NUCLEAR REACTOR LABORATORY
AN INTERDEPARTMENTAL CENTER OF
MASSACHUSETTS INSTITUTE OF TECHNOLOGY

Subject: SAR Revision No. 31, License No. R-37, Docket No. 50-20

SAR Revision No. 31

FIGURE 9.3.1-1
REACTOR FLOW SYSTEM

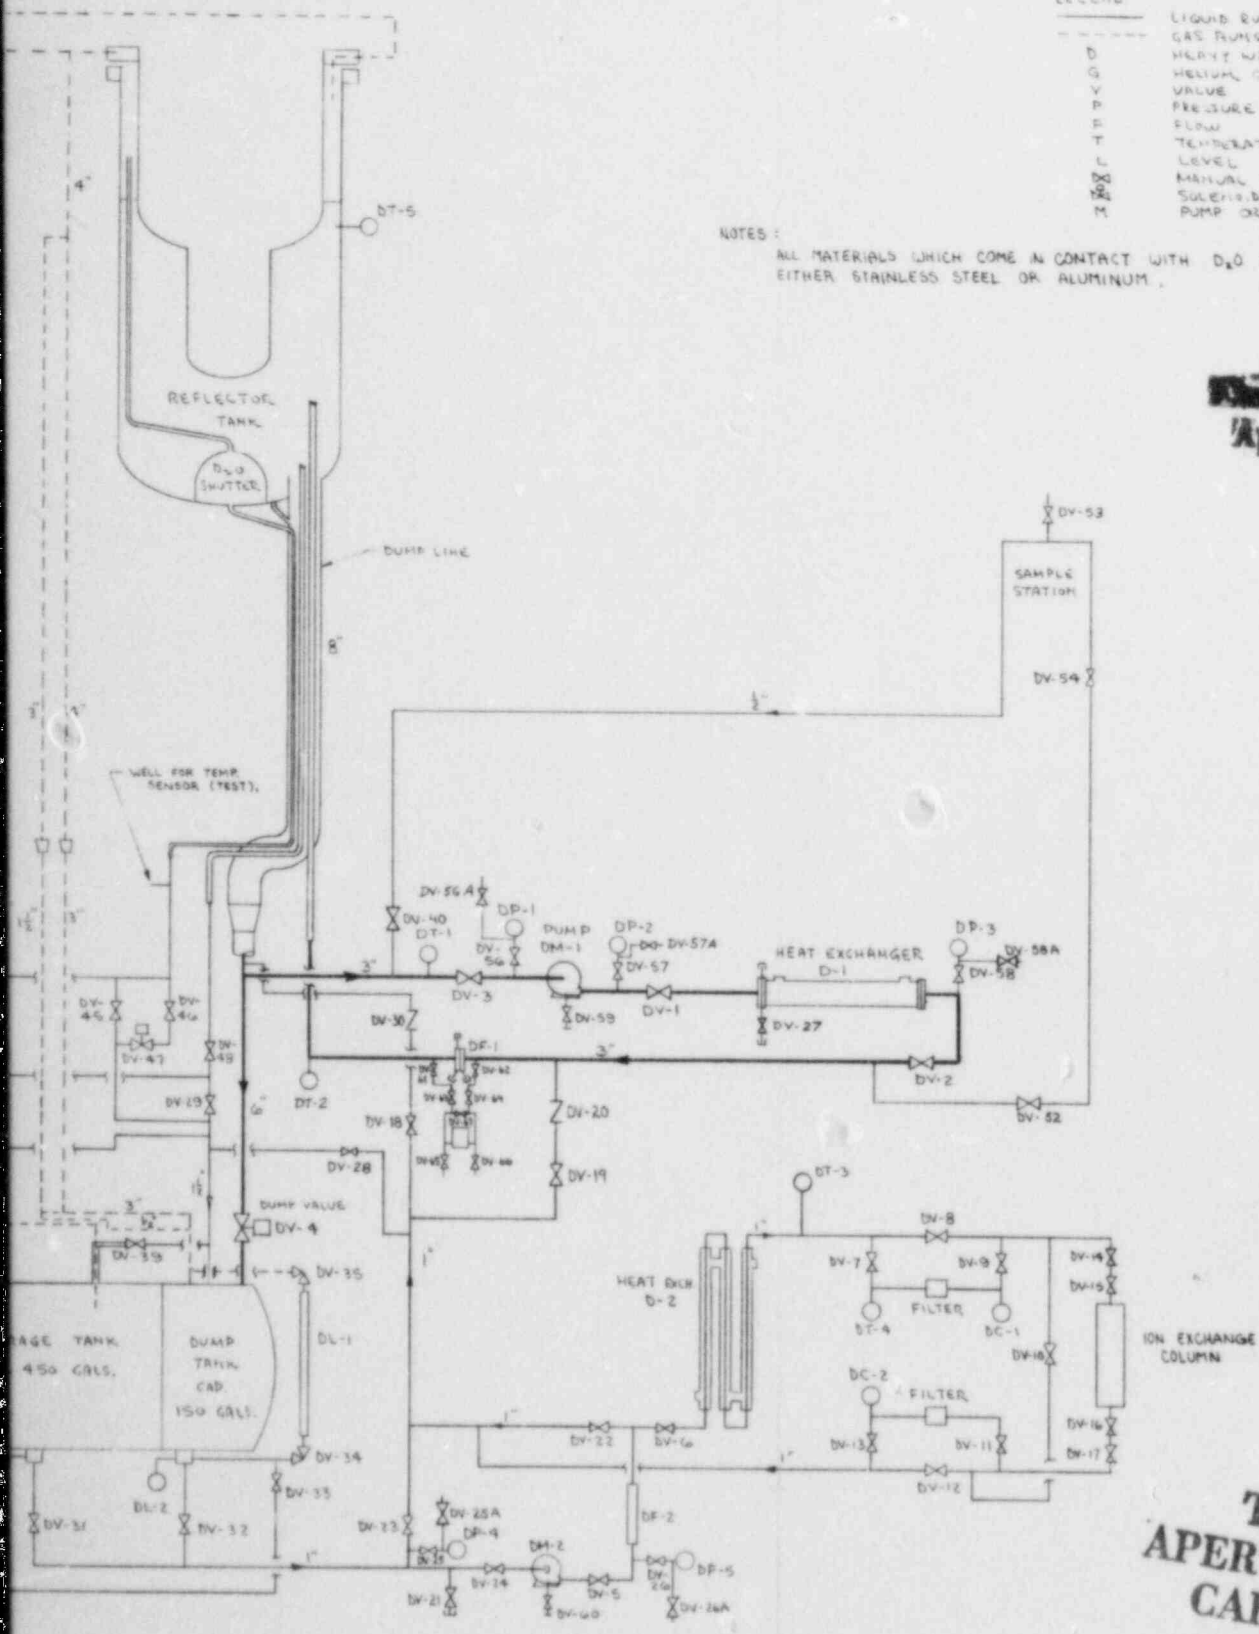
<u>Remove</u> <u>Page</u>	<u>Insert</u> <u>Page</u>	<u>Description of Change</u>
Fig. 9.3.1-1 (9/24/76)	Fig. 9.3.1-1 (9/16/83)	Figure updated to include valve DV-69 which is normally locked open but can be used to isolate the helium cover gas system when the blow off patch is serviced.
